## Summary of Items Discussed in APSEC Discussion Forum (ADF) 4/2025 on 21 November 2025

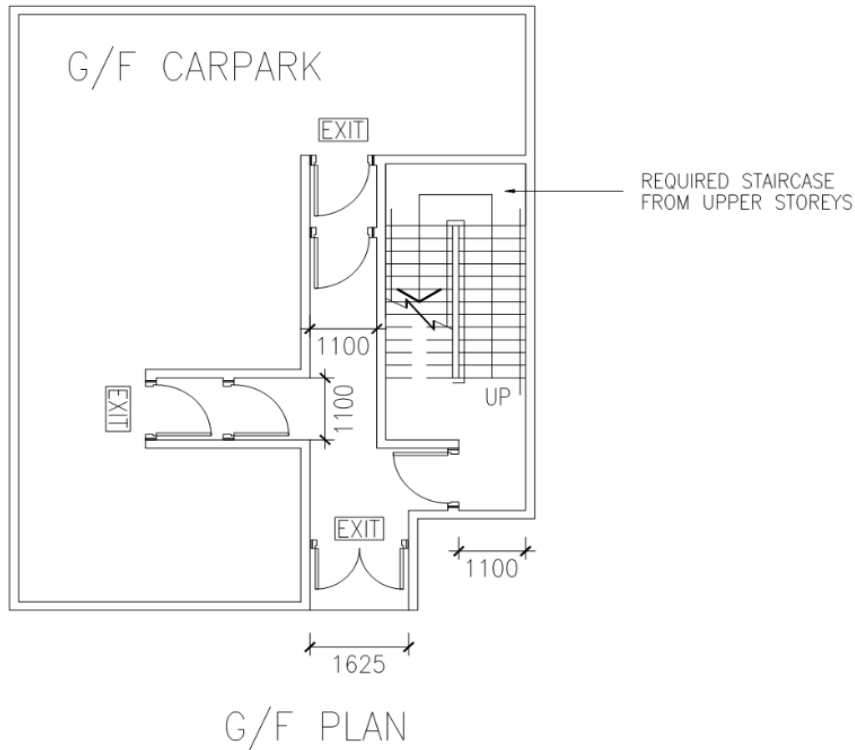
<p>3.</p>	<p><b><u>FS Code - Exit at Ground Storey</u></b></p> <p>According to Clause B9.2 of the FS Code, an exit route from a ground storey also forms part of the exit route from a required staircase, the width of such exit route should be not less than the sum of half the width required for the exit route from the ground storey and the width required for the required staircase.</p> <p>For cases with multiple exits provided at ground storey leading to the same protected exit, it is our understanding that the required aggregate exit width should not be increased solely based on the number of exit doors provided, provided that:</p> <ol style="list-style-type: none"> <li>1. The exit doors lead from the same room/compartment on the ground storey;</li> </ol>	<p>BD advised that the understanding of HKIA was correct. It was clarified that the occupant capacity of the car park as shown in the diagram did not exceed 30 persons. However, the minimum width of combined exit route in the diagram should be 1 650mm and measured between the vertical member of the door frame.</p>

Would BD please confirm if our understanding is correct and the example in the below diagram is acceptable?

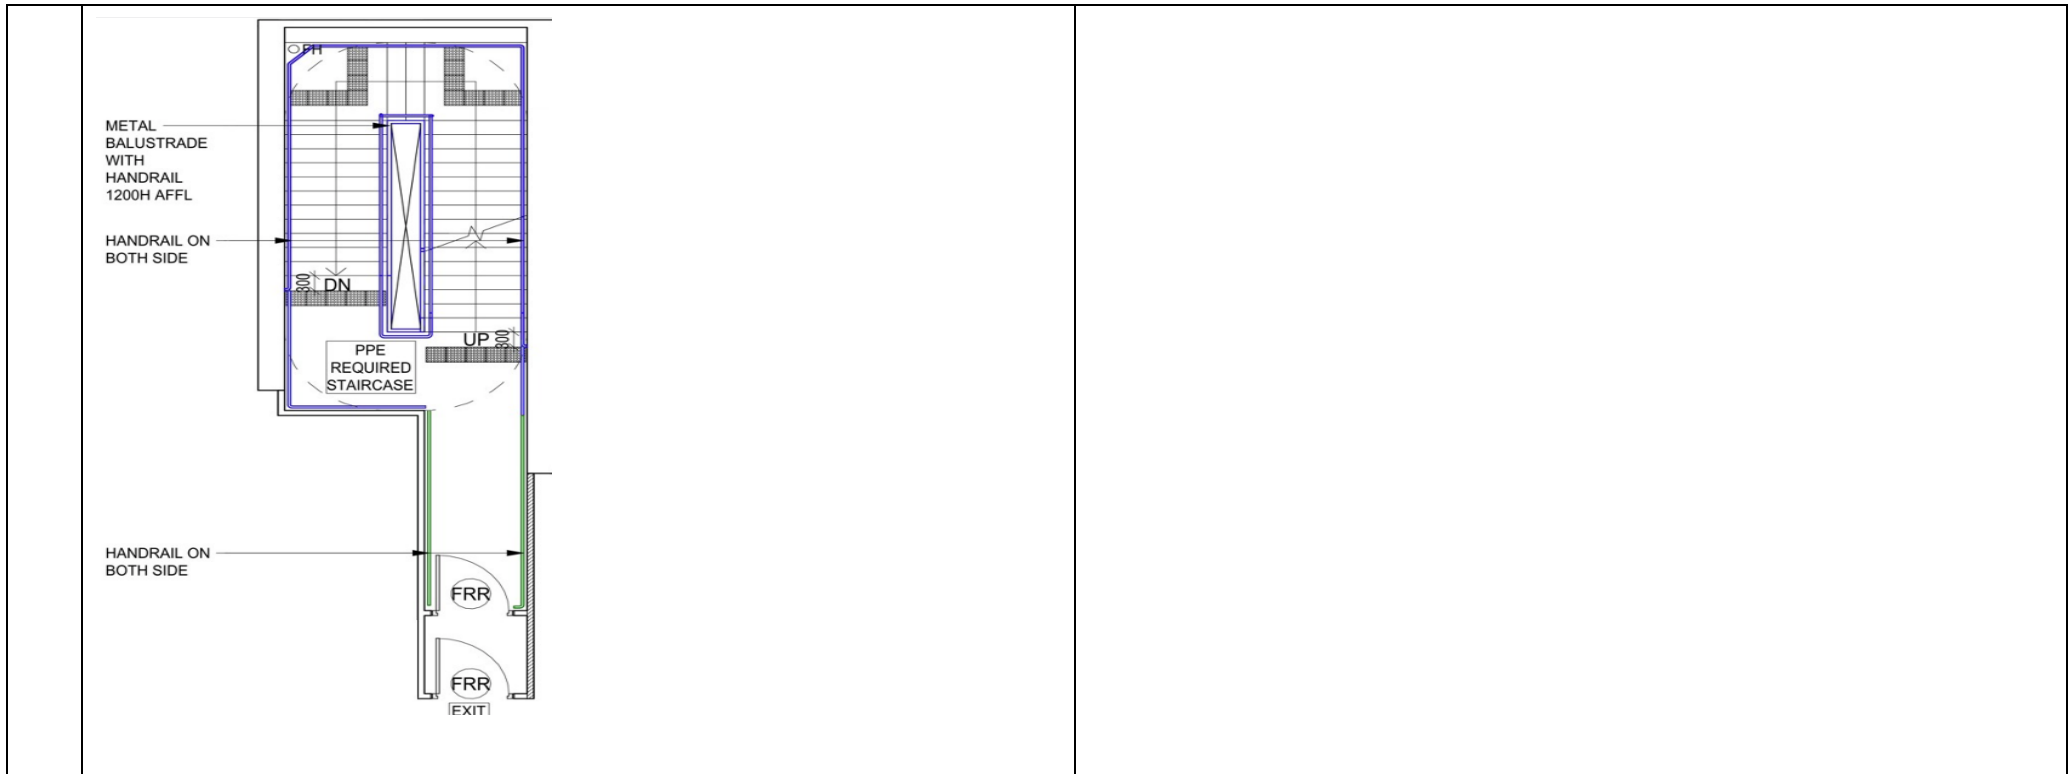
5.	<p><b><u>FS Code – Handrail on each side of the required staircase</u></b></p> <p>According to Clause B14.6(c) of the FS Code, handrail on each side of the required staircase shall be continuous throughout each flight, but need not be carried round a landing or half landing except in the case of premises of Use Classification 5a.</p> <p>It is our understanding that the handrail highlighted green in the below diagram shall not be required. Would BD please advise if the understanding is correct?</p>	<p>BD advised that the understanding of HKIA was correct. Nevertheless, BD reminded that the provision of staircase handrails should comply with all relevant requirements as stipulated in the Design Manual: Barrier Free Access 2008 (2025 Edition).</p>

**Scenario 2**

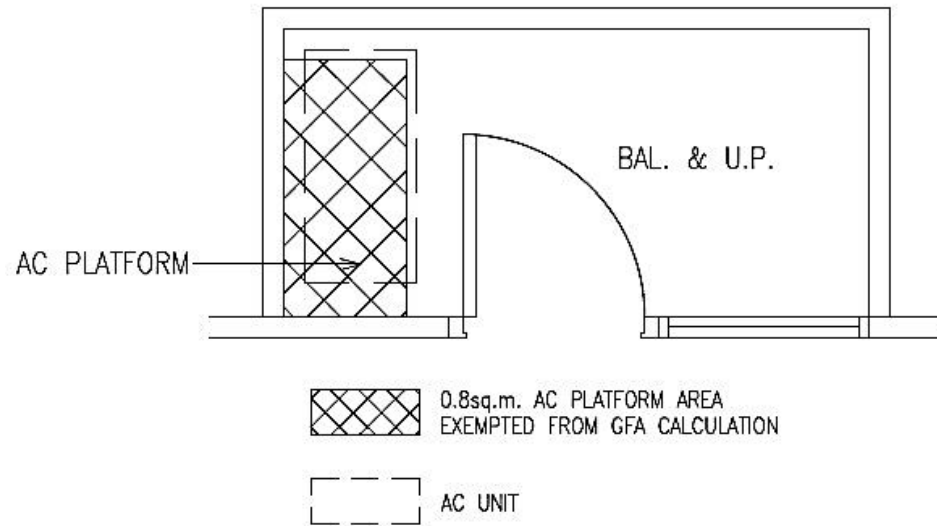
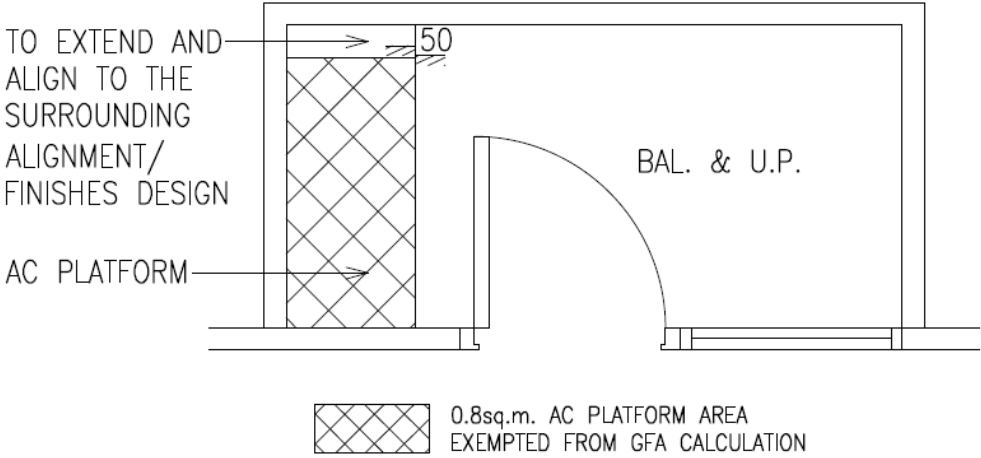
7.	<p><b><u>Air-conditioner (AC) platform combined with Balcony / Utility Platform (UP)</u></b></p> <p>According to item (b) of Appendix B to the Code of Practice on Access for External Maintenance 2021 (2024 Edition) , “<i>a minimum of 50mm rise in level from the finished floor of the balcony/UP should be provided in the AC platform</i>”.</p> <p><b>Scenario 1</b></p> <p>To cater for the intake and exhaust systems of some large size AC outdoor unit as found in the market, would BD accept a portion of the AC outdoor unit be positioned outside the prescribed 0.8m<sup>2</sup> AC platform area as shown in the below diagram.</p>	<p>BD advised that both arrangements in Scenario 1 and Scenario 2 were considered acceptable, provided that the AC outdoor unit could be securely installed on the AC platform.</p> <p>For Scenario 2, the remaining portion could be accounted towards the balcony/UP area given that the proposed concession area of the balcony/UP after deducting the 0.8 m<sup>2</sup> of AC platform met the criteria under JPN Nos. 1 and 2. Item 1 of ADF 5/2021 held on 21 November 2021 was relevant.</p>

For ease of construction, would BD accept the extent of AC platform area under Scenario 1 be modified as illustrated in the below diagram in such a way that the entire raised AC platform area becomes larger than 0.8m<sup>2</sup> but only the 0.8m<sup>2</sup> (the cross-hatched portion) will be GFA exempted, the remaining portion is accounted towards the Balcony / UP area.

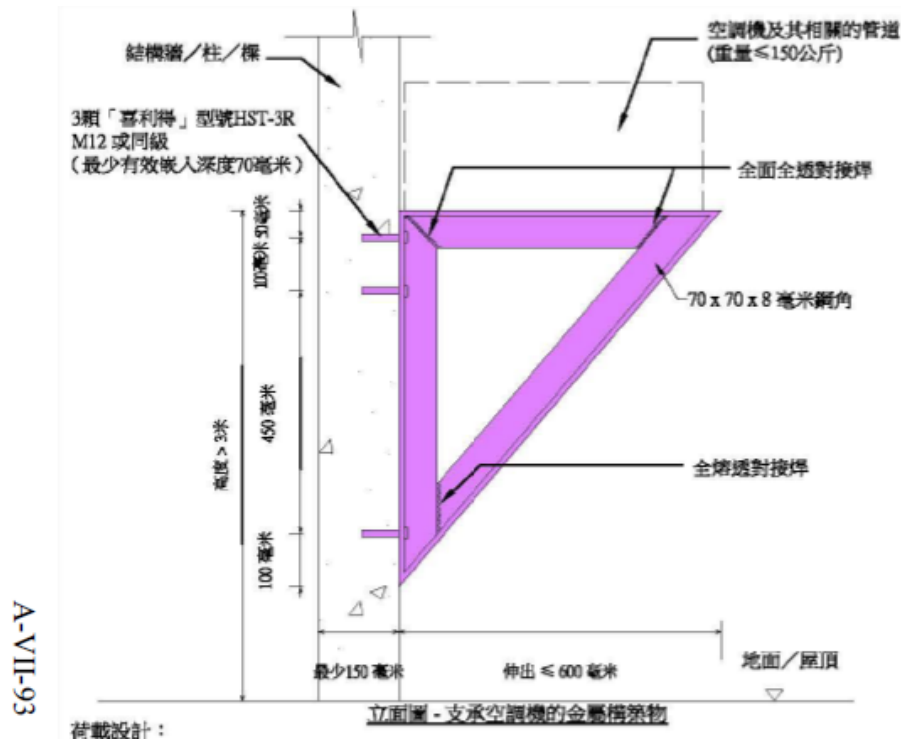
With reference to the recommended design and details for minor works item 2.49 in Appendix VII of Technical Guidelines on Minor Works Control System (2024 Edition) as shown below, it specifies the parent structure of such supporting frames shall be either structural wall / column / beam with minimum thickness of 150mm.

<p>Would BD please clarify the necessity to follow such supporting requirement to classify the supporting frames of air-conditioning unit as minor works item 2.49.</p>	
<p><b>AOB Items</b></p>		
<p>12.</p>	<p><b><u>Horizontal Screens/Covered Walkways</u></b> (Item raised by HKIA)</p> <p>In paragraph 20(a) and 20(b) of PNAP APP-42, it states that “<i>horizontal screens/covered walkways are in communal outdoor passageways at ground floors or podium floors; the horizontal screens/covered walkways should be an open-sided structure and connect directly:</i></p> <p><i>(i) the main initial access at the lot boundary to the main entrance of a building; and/or</i> <i>(ii) the main entrances between buildings.”</i></p> <p>We would like to clarify that:</p> <ul style="list-style-type: none"> <li>- whether the horizontal screen / covered walkway <b>open on one side</b> is considered as an open-sided structure.</li> <li>- whether the main entrances between buildings include the <b>entrances to recreational facilities for residential developments and carparking facilities.</b></li> </ul>	<p>BD advised that the horizontal screens/covered walkways to be exempted from GFA and site coverage calculations under paragraph 20 of PNAP APP-42 should be open-sided as far as possible and the design would be considered on case basis.</p> <p>The main entrances between buildings under paragraph 20(b)(ii) of PNAP APP-42 include the entrances to the buildings of recreational facilities and car parks.</p>

III minor works in the Technical Guidelines on Minor Works Control System (2024 edition) were provided for Prescribed Registered Contractors' (PRC) reference only. The appointed PRC should assess the structural capacity of the supporting member and ensure the proposed works are safe and stable against all conditions.
